**SUBJECT: RESPONSE TO THE NOTICE OF DEFICIENCY (NOD) FOR
POTENTIAL RELEASE SITES IN TECHNICAL AREA (TA) 39**

Document Title: Response To The Notice Of Deficiency For Potential Release Sites In Technical Area 39

NOTICE OF DEFICIENCY COMMENTS
RFI REPORT TA-39

Figure 1-1. Location of Los Alamos National Laboratory and TA-39 (Operable Unit 1132).

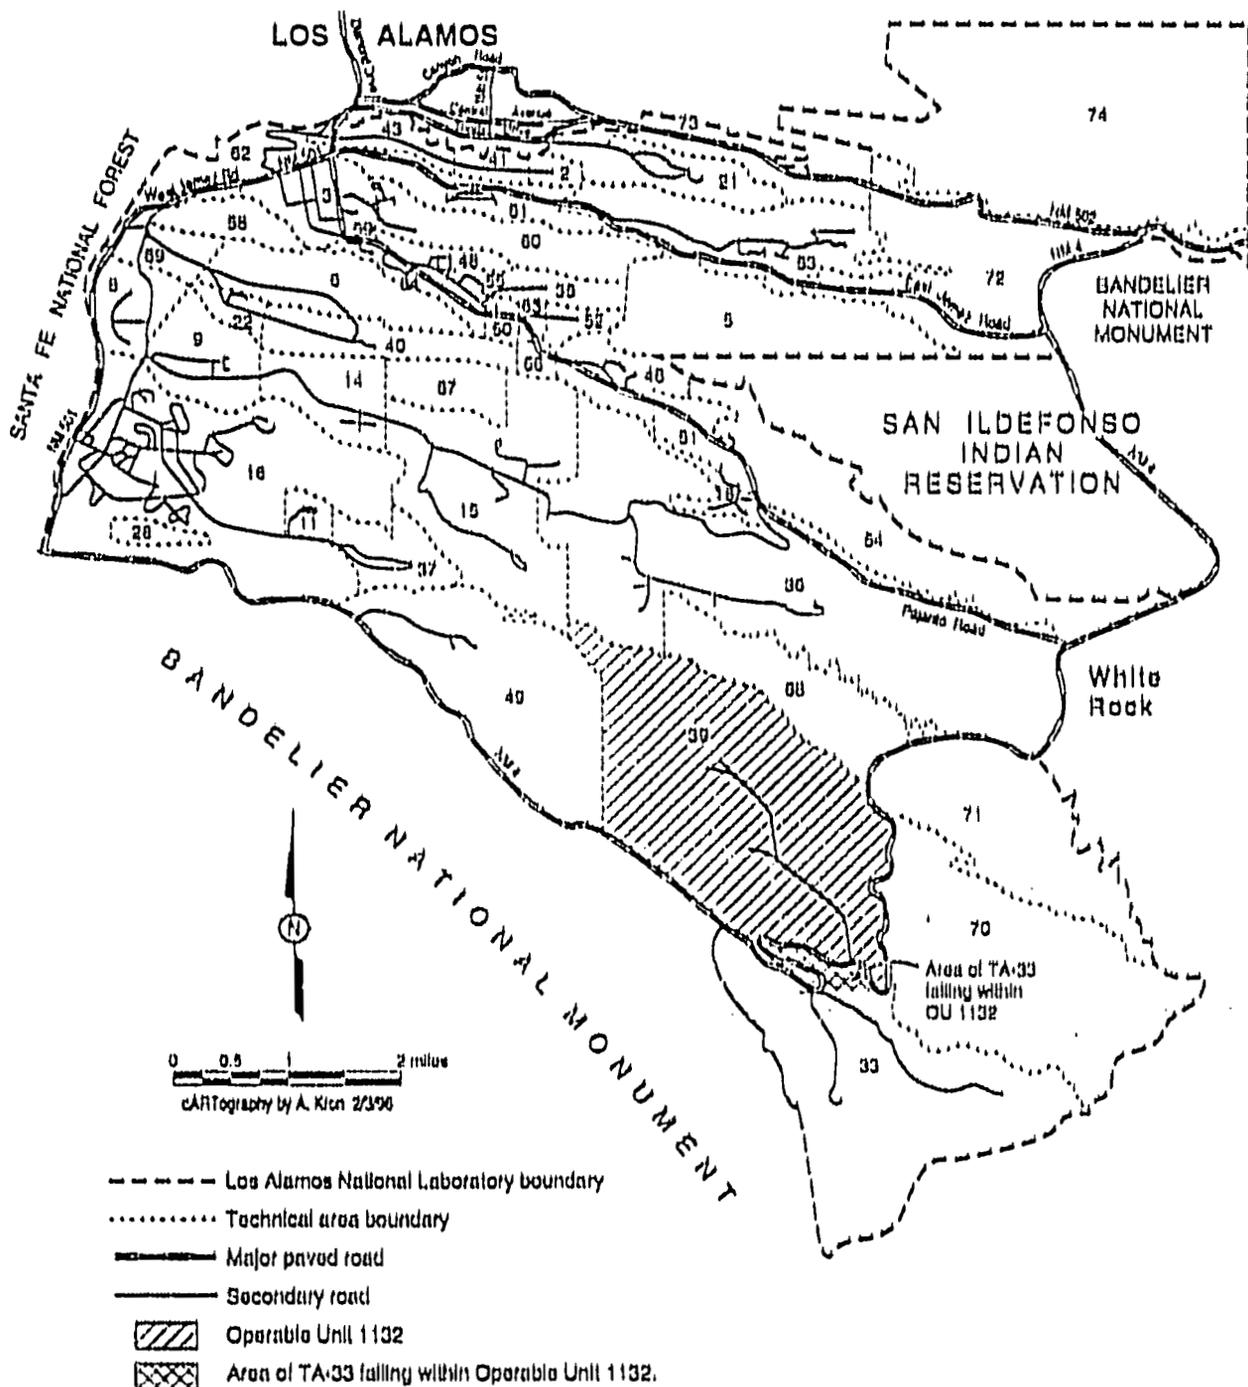
Comment 4: *Figures 1-2, 1-3, and 1-4 are confusing, because several sets of numbers used to identify or describe different facilities—such as building numbers, PRS numbers, and TA numbers—are not explained in the figure legends. For each figure, provide a definition in the legend for the numbering systems used. Also, present a single map indicating the boundaries of the north, central, and south portions of OU 1132 shown on these figures.*

Discussion: The referenced figures have been revised to better clarify the information being presented. In addition, Figure 1-1 has been modified to more clearly illustrate the northern, southern, eastern, and western boundaries of OU 1132. Figure 5-7 in the RFI Work Plan illustrates the locations of the north, central, and south portions of OU 1132.

Proposed Text Changes: Replace the original Figures 1-1, 1-2, 1-3, and 1-4 with the revised Figures 1-1, 1-2, 1-3, and 1-4.

Figure 4-1. PRS 39-002(a) Area 1—storage area at TA-39-2, sampling locations 39-1051 and 39-1053.

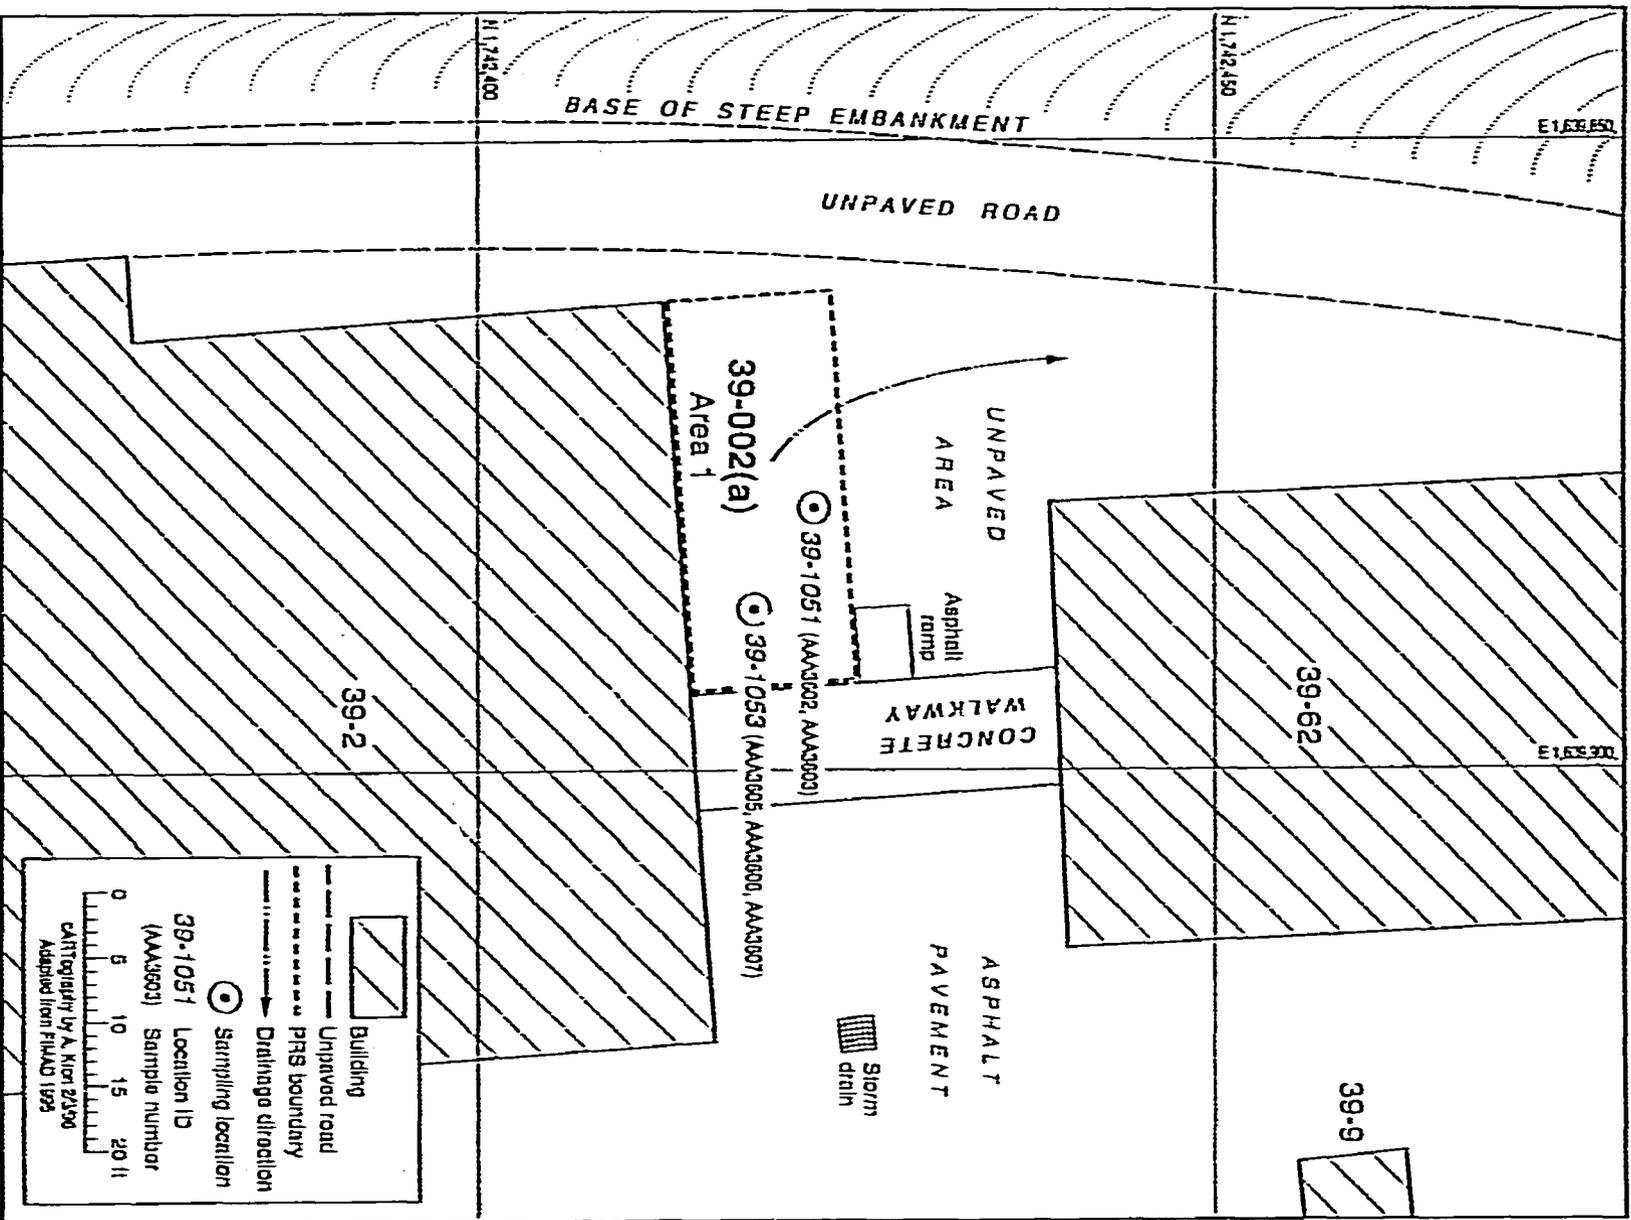
Comment 13: (Chapter 4, PRS 39-002(a), Figure 4-1, page 4-3). Designate Areas 1, 2, and 3 on Figure 4-1.

Discussion: The only area designated on Figure 4-1 is Area 1. Area 2 is situated inside of Building TA-39-2 and Area 3 is on the southern end of this building, which is not represented in the figure. Consequently, neither Area 2 nor Area 3 appears on Figure 4-1. However, we have modified the figure to illustrate more clearly the location of Area 1.

Proposed Text Changes: Replace the original Figure 4-1 with the revised Figure 4-1.

Figure 4-7. PRS 39-007(a)—storage area at TA-39-63, sampling locations 39-1065, 39-1066 and 39-1067.

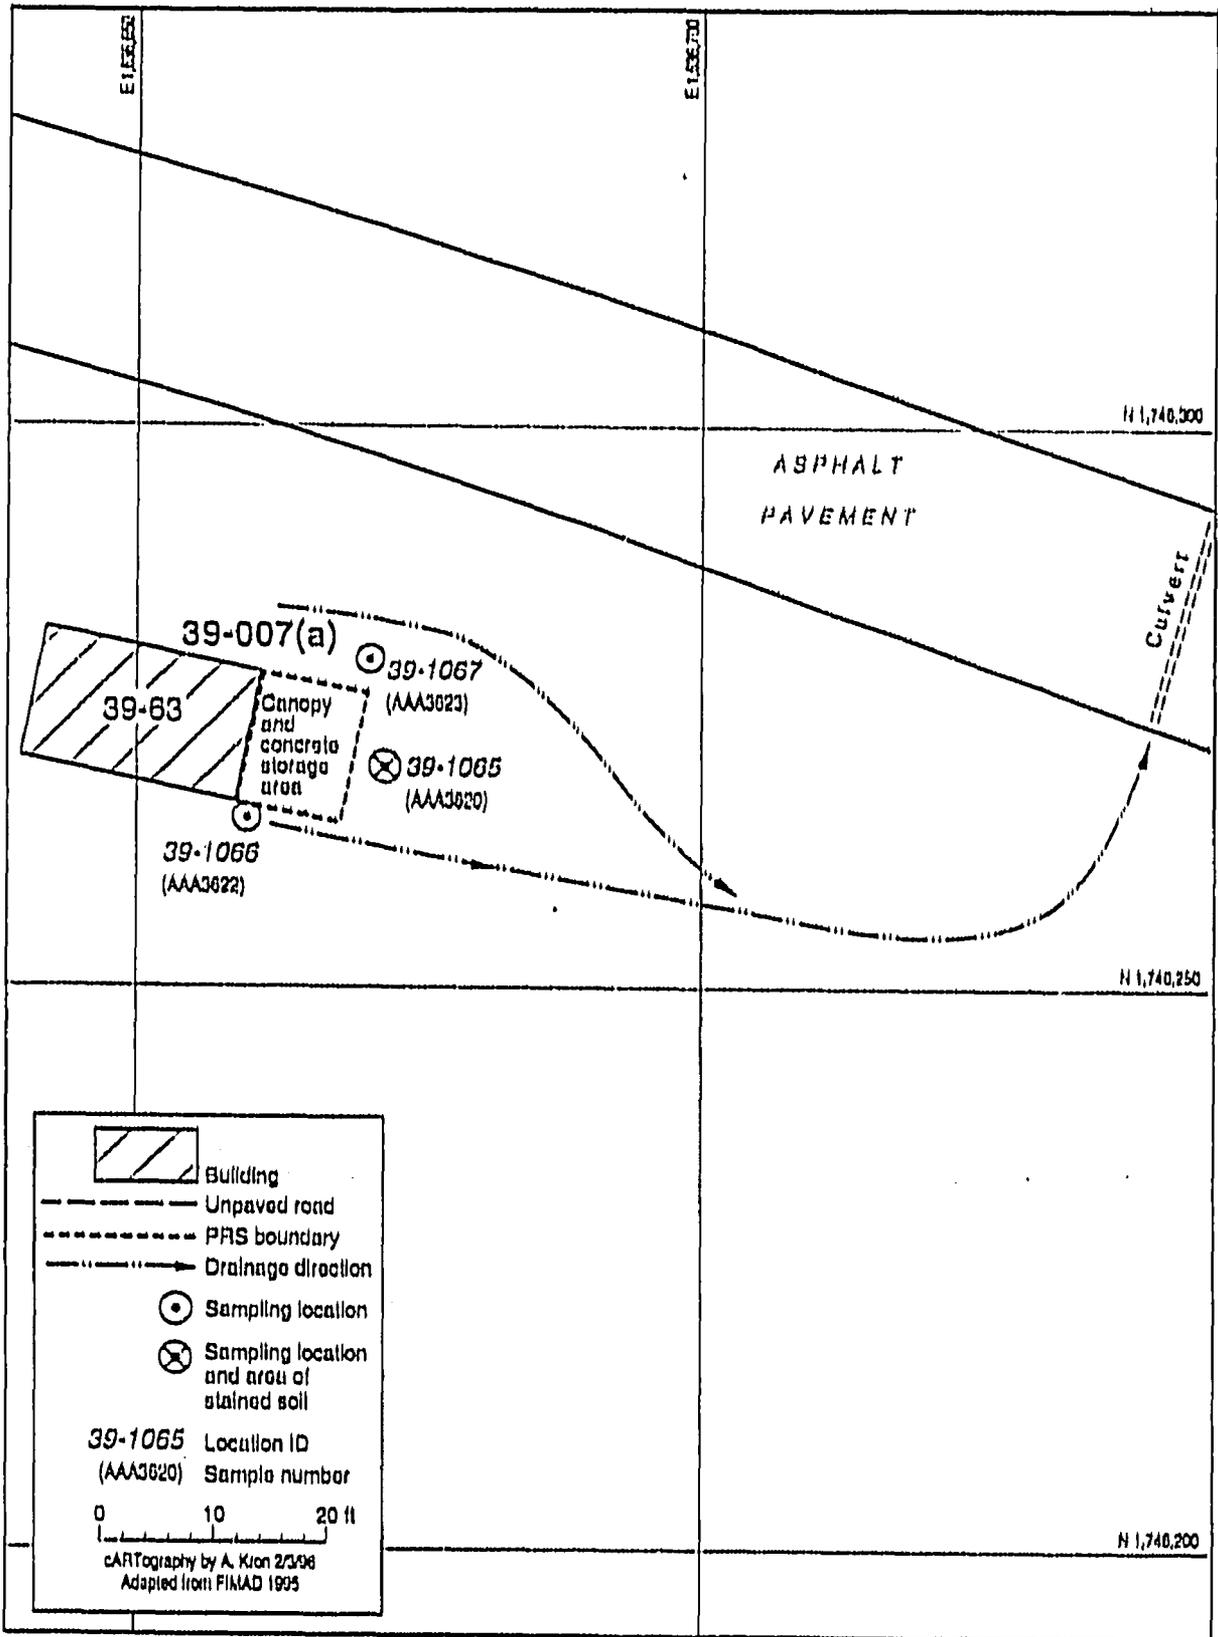
Comment 25: (Chapter 4, PRS 39-007(a), Figure 4-7, page 4-34). The figure does not clearly show whether soil samples were collected from the stained soil. LANL should modify the figure to show the area of stained soil. LANL should also justify its selection of sampling locations, because soilman/soil samples were not collected from drainage pathways as they were at PRS 39-002(e) and 39-002(f).

Discussion: A revised Figure 4-7 is attached. Sampling was conducted as close to the potential source as possible and within the area of the stained soil (see response to Comment 7 for detailed rationale).

Proposed Text Changes: Replace original Figure 4-7 with revised Figure 4-7.

Figure 4-8. PRS 39-007(d)--storage area at TA-39-142, sampling locations 39-1068, 39-1070 and 39-1071.

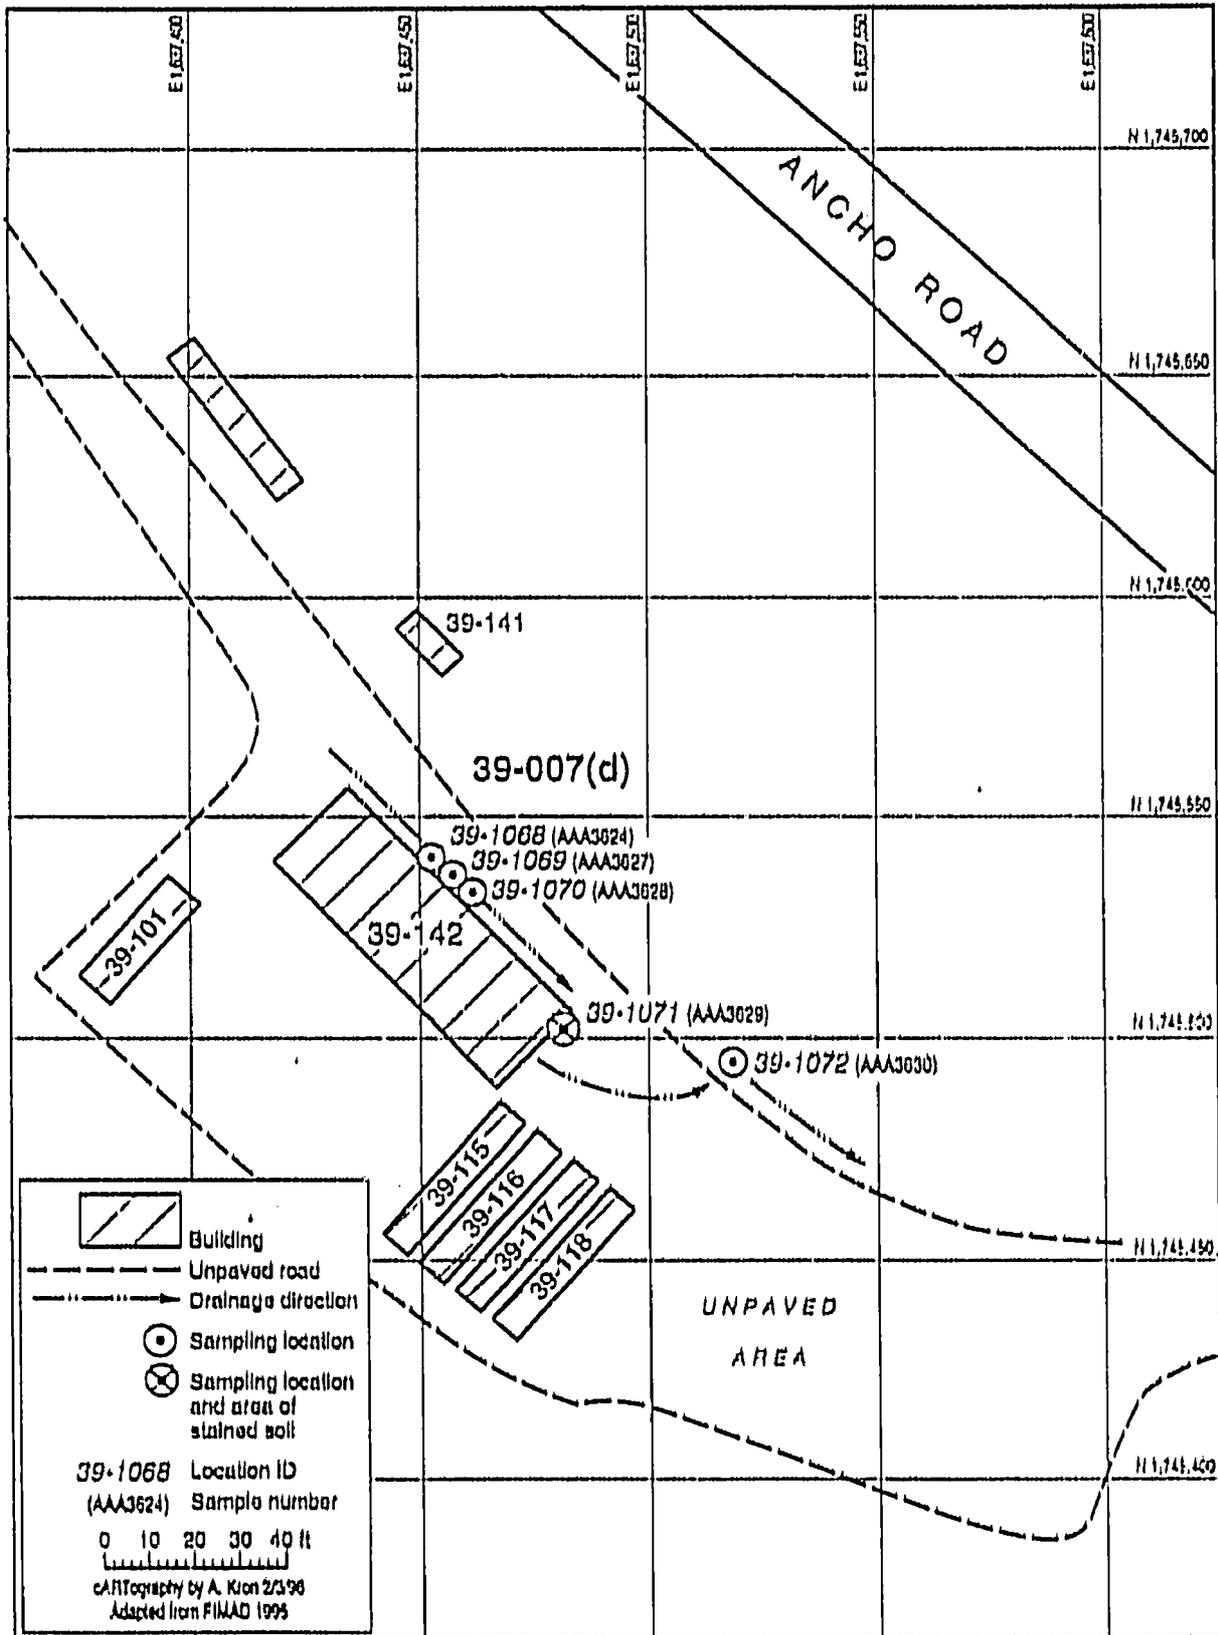
Comment 28: (Chapter 4, PRS 39-007(d), Figure 4-8, page 4-38). The figure does not clearly show whether soil samples were collected from the stained soil. Modify the figure to show the area of stained soil.

Discussion: So modified.

Proposed Text Changes: Replace original Figure 4-8 with revised Figure 4-8.
